# Government of the District of Columbia

## Department of Transportation

#### MEMORANDUM

**SUBJECT:** ZC Case No. 24-12 – 4201 Garrison Street NW

**Figure 1 | Site Plan**

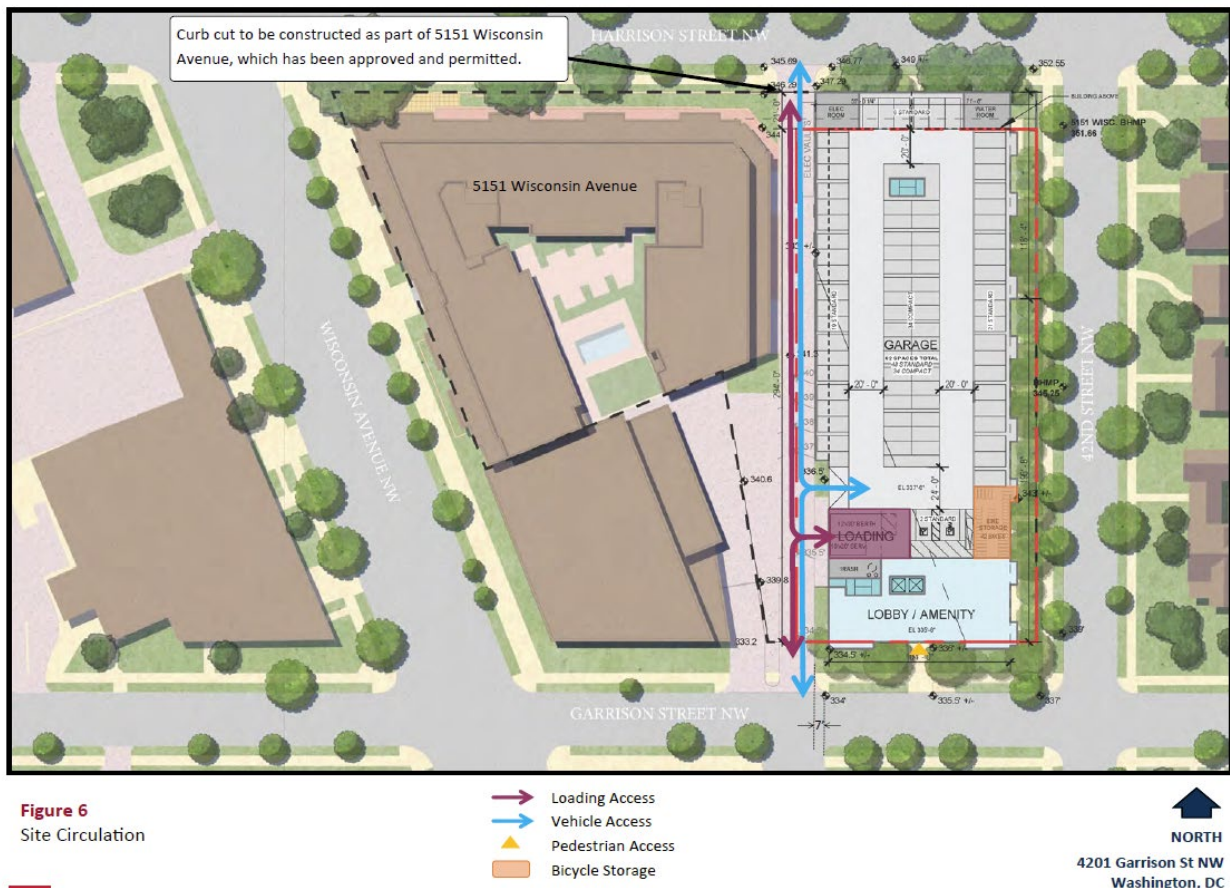
While the preliminary public space plans, shown above in Figure 1, are generally consistent with DDOT standards, there are several considerations that need to be reviewed in greater detail during the public space permitting process:

- There are building restriction lines (BRL) along both 42<sup>nd</sup> Street and Harrison Street. The area between the property line and BRL is regulated as if it were DDOT public space and should be as green and 'park-like' as possible with compliant vaults;

- All vehicular site access to the site, as well as loading facilities and trash pick-up, must be via the proposed rear private alley;
- The existing curb cut to the private alley on Garrison Street should be designed to DDOT standard and include a pedestrian refuge island between it and the neighbor's curb cut;

- The Applicant should implement the following infrastructure improvements in public space, subject to DDOT approval:
  - Add intersection daylighting on all four corners at either the intersection of Garrison and 42<sup>nd</sup> Street NW or Harrison and 42<sup>nd</sup>;

- Construct a speed hump on 42<sup>nd</sup> Street NW
- All building entrances must be at grade with the sidewalk so that no stairs or ramps will be necessary in public space;

**Figure 4 | Existing Bicycle Facilities**

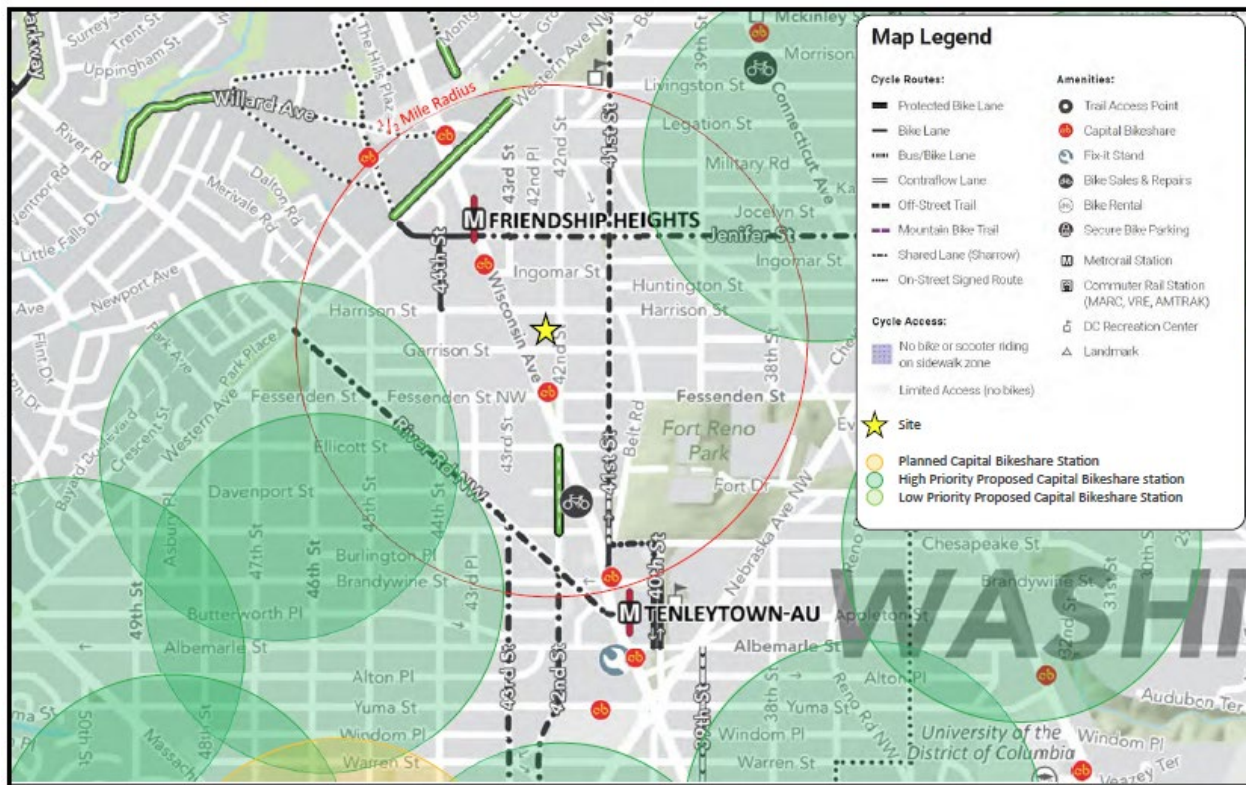
As shown below in Figure 4, there are currently only a few unconnected bicycle lane segments in the vicinity of the site but there is a DDOT project in planning to improve the existing bike lanes along Jenifer and 44<sup>th</sup> Streets NW with protected facilities as well as install a new protected bike lane from Jenifer Street NW southwest along Western Avenue toward Massachusetts Avenue NW. There are also four Capital Bikeshare stations within ½ -mile of the site.

**Figure 5 | Proposed Curbside Designations**

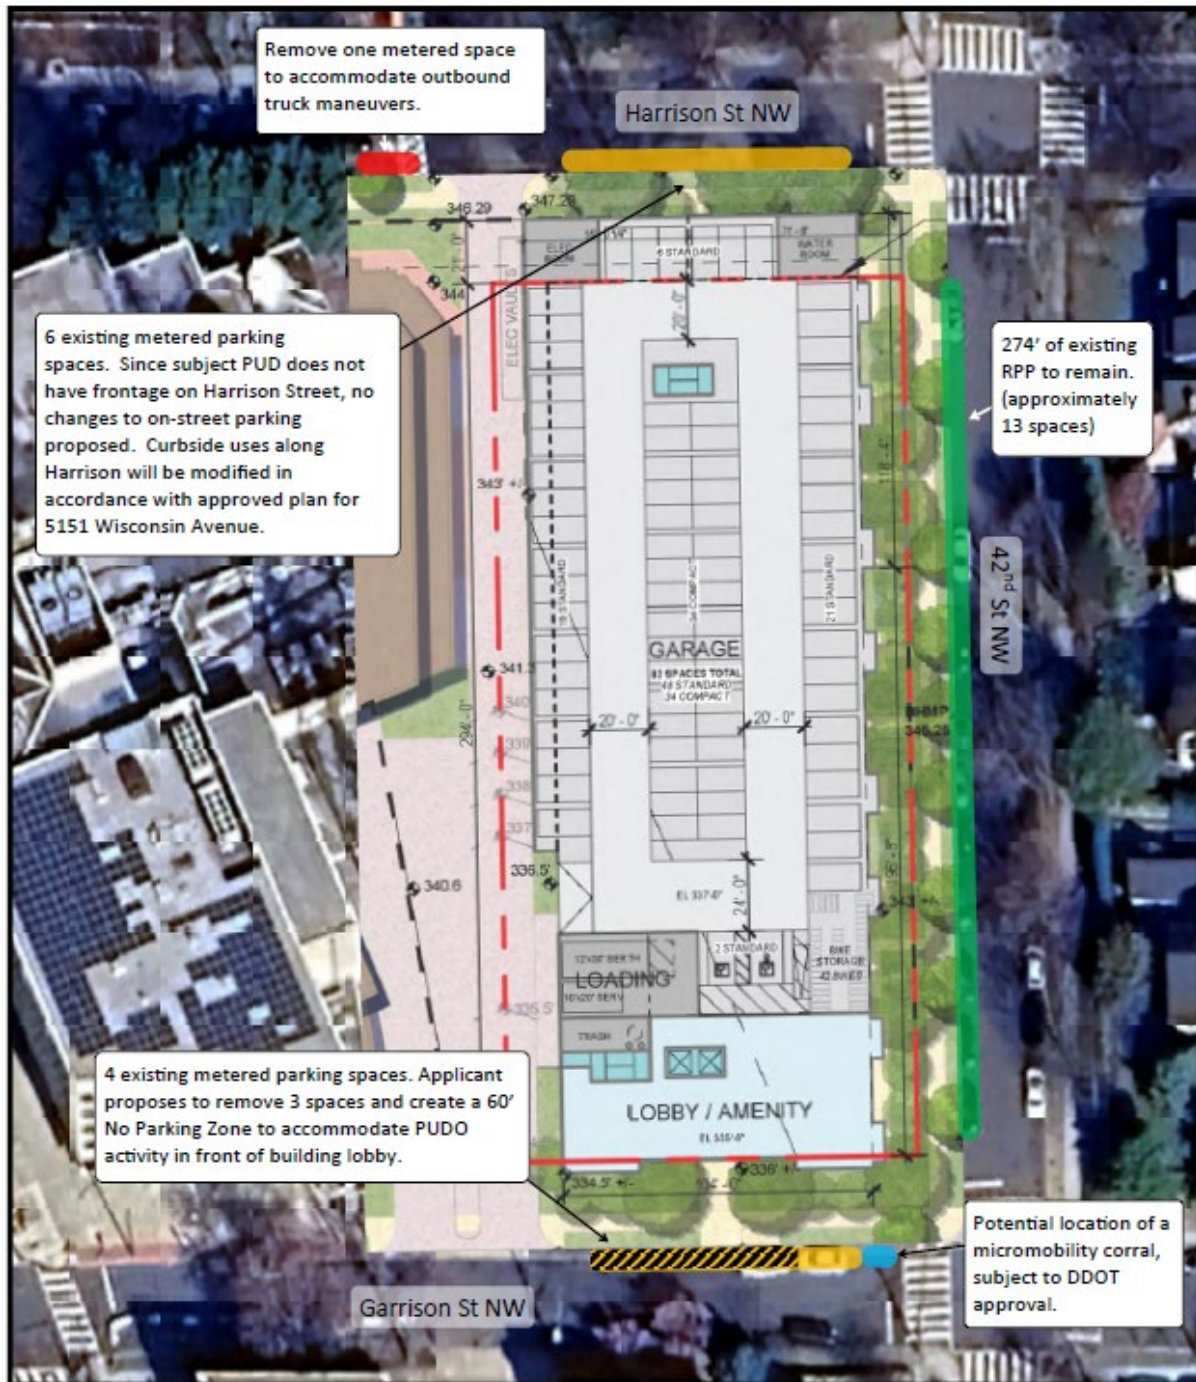
The site currently has metered curbside parking along both the Harrison Street NW and Garrison Street NW frontages and Residential Permit Parking (RPP) on the 42<sup>nd</sup> Street NW frontage. As shown below in Figure 5, the Applicant is requesting an on-street pick-up/drop-off zone (hatched yellow and black) near the building entrance on Garrison Street NW while leaving the remainder of the blocks as metered and RPP, respectively.

DDOT is generally supportive of this concept, however, a detailed curbside and signage plan must be submitted during public space permitting for review and approval by DDOT's Curbside Management Division (CMD). At that time, the plan may be refined by CMD and the exact signage placards will be determined. If multi-space meters are required by CMD then they will be at the Applicant's expense.
